DATE MAILED: 12/06/2006

| Office Action Summary | Application No. 10/538,553 | Applicant(s) BUEHLER, JUERGEN | |

The following correspondence is a non-final Office Action for application # 10/538,553, entitled: Swivel Arm Assembly for Plumbing Fixtures, filed on 06/13/2005. Claims 1-18 are pending.

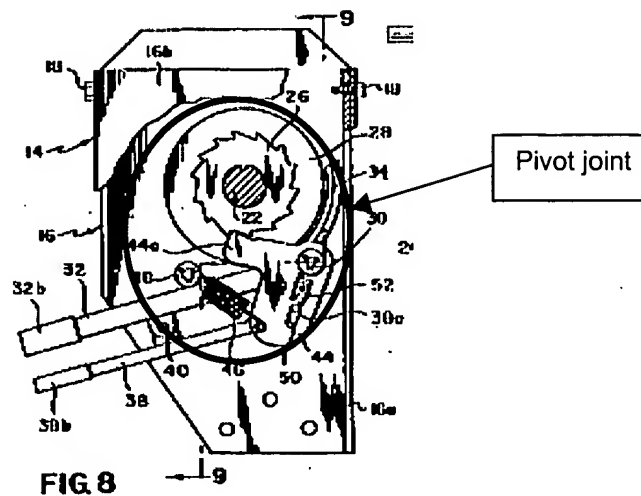
Regarding claim 1, Cohrs discloses an articulated-arm assembly, comprising: a mounting fixture **16** for fastening the assembly in place, an arm **24** jutting out of the mounting fixture **16**, a pivot joint (shown in Fig. 8 below) for joining the arm **24** to the mounting fixture **16**, a brake **28, 34** for locking the arm **24** in place, and a ratchet **26** that allows pivoting of the arm **24** in one direction.

With regards to claim 4, Cohrs discloses the articulated-arm assembly, where the ratchet **26** acts on a sleeve or collar **24a** while joined relative to the arm **24**.

Regarding claim 5, Cohrs further teaches the articulated-arm assembly, where the ratchet **26** has a pawl **44a** arranged on the mounting fixture **16** and where the pawl **44a** has a length equaling that of the sleeve or collar **24a**.

Regarding claim 16, Cohrs discloses the articulated-arm assembly, where a space accommodating at least one of the brake and the ratchet is sealed with respect to the ambient (as shown in Fig. 8).
